January 12, 2025

Chairman Fon, Planning Board Members, and Councilman Esposito,

As a resident whose property will be directly impacted by this project we are writing to oppose the construction of a driveway and cell tower at 62 Granite Springs Road. Please forward our letter in opposition to both the Town Board and the Planning Board. Please also confirm receipt of our letter by emailing us back. We have several reasons for opposing the construction of a driveway and cell tower at 62 Granite Springs Rd that need to be considered by the Planning Board.

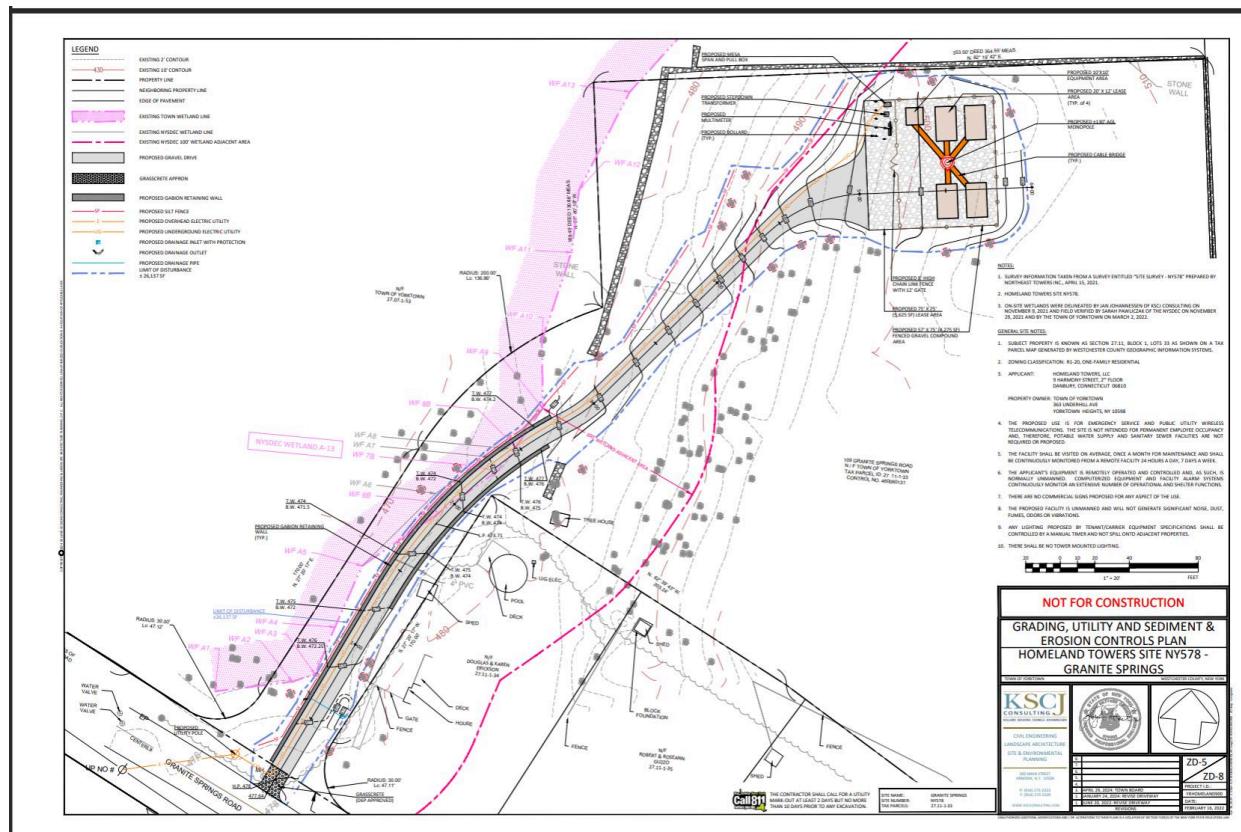
John and Robyn,  
Per our earlier discussion and review of the NY578 Granite Springs ZD – Design – Draft 6-22-22\_p3 PDF (attached), I offer the following comment:

- it appears that the revised federal and Town wetland jurisdictional boundary that was demarcated with the client in the field is depicted west (or wetland ward) of the NYSDEC validated wetland boundary, based on the figure's line types and locations. The line type for the NYSDEC wetland boundary should follow flags WF A6, WF A7, WF A8; while the field adjusted boundary should be depicted to the east of the NYSDEC wetland boundary and recognized by flag locations WF 6B, WF 7B, and WF 8B.

Aside from this needed modification, the boundaries appear to be shown accurately.  
If you require additional support related to this project, please let me know. Many thanks, ~Johanna

Figure Y11: Predicted LTE Coverage Northern Yorktown

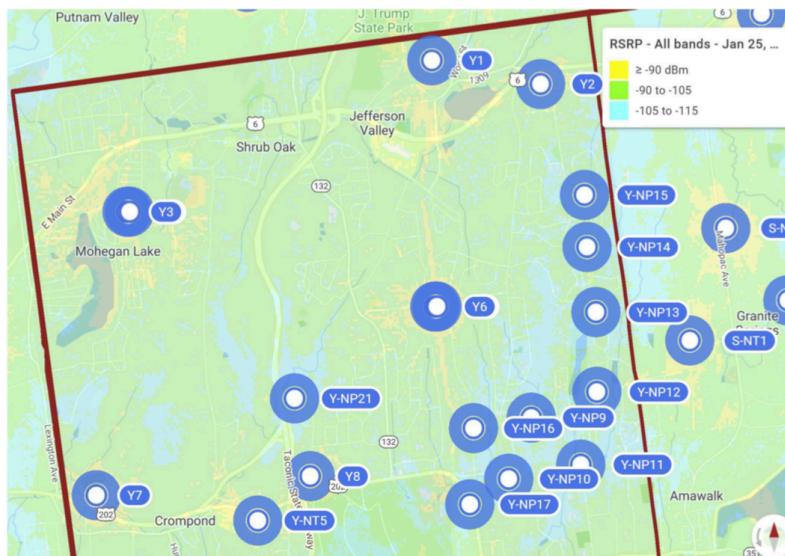
This report has been referred to on multiple occasions by the Town Board and Homeland Towers as justification for this macro tower. However, the report does not recommend a macro tower in this location. It actually recommends several small wireless facilities on either existing infrastructure or 50ft poles within the entire northern part of town with one macro tower in the Crompond area. Of the recommended smaller sites only a few are needed in the area in question due to the reported small coverage gaps referenced in the report. The chairwoman questioned why smaller poles were not being utilized in place of a macro tower at the Jan. 7, 2026 Conservation Board meeting. The attorneys, Mr. Kenny and Mr. Xavier representing Homeland Towers responded that they did not know if the town would allow them to have access within the town right of way along the roads. This implies that there was no effort to implement the recommendations in this cellular plan that would provide coverage and not require the proposed disturbance of the current plan. The Town Board has the ability to provide increased coverage without this project and should do its due diligence to request proposals for the smaller less invasive infrastructure. It provides the balance that is needed to protect the environment, the neighborhood character and provides the ability to improve cellular coverage.
